Subject: George Hotel, Huddersfield (2025/91147 and 2025/91148) - Waste Collection Calculation

Collection location as indicated below

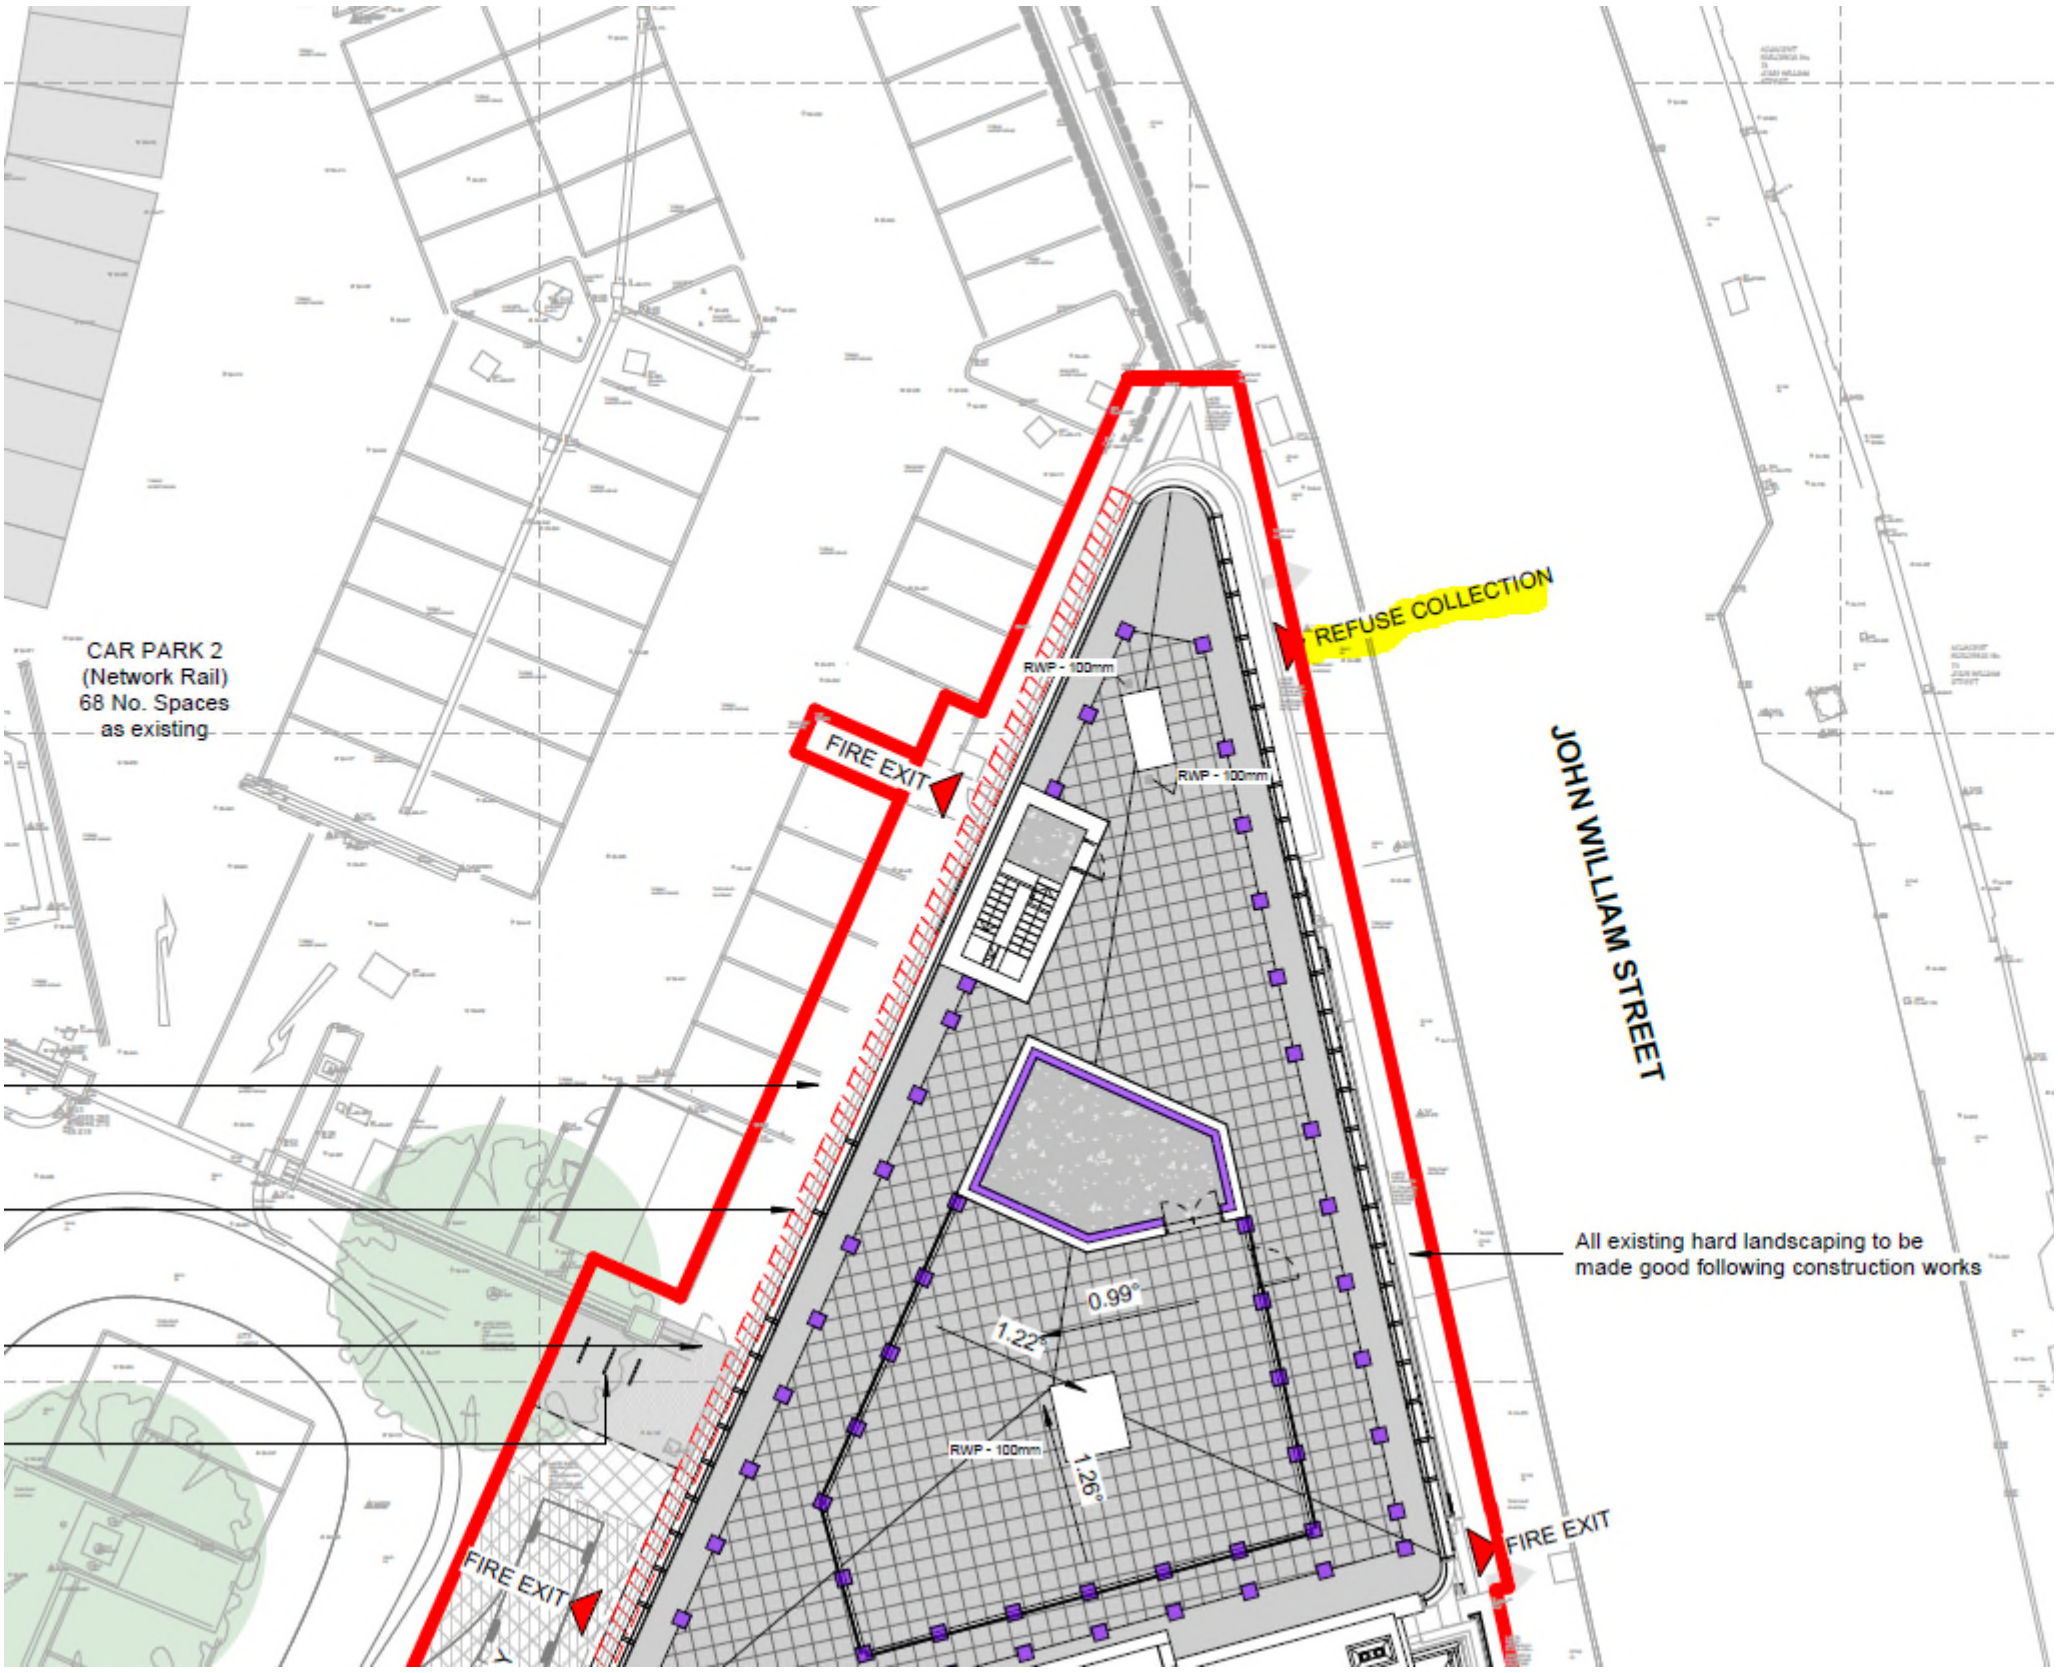
- **Waste Volume:** It is proposed that the waste storage and collection zone shall ostensibly be served by 8nr bins (compactor assisted) collected tri-weekly with separate arrangements made specifically in extreme circumstance (event management arrangement).
- **Highway Safety:** The refuse store is to be located at Ground Floor level on John William Street at the furthest North of the site so as the present the minimum risk of vehicular impact on collection.
- **Visual Amenity:** As indicated below, it is proposed that all waste shall be internally stored until collection (staff assisted).
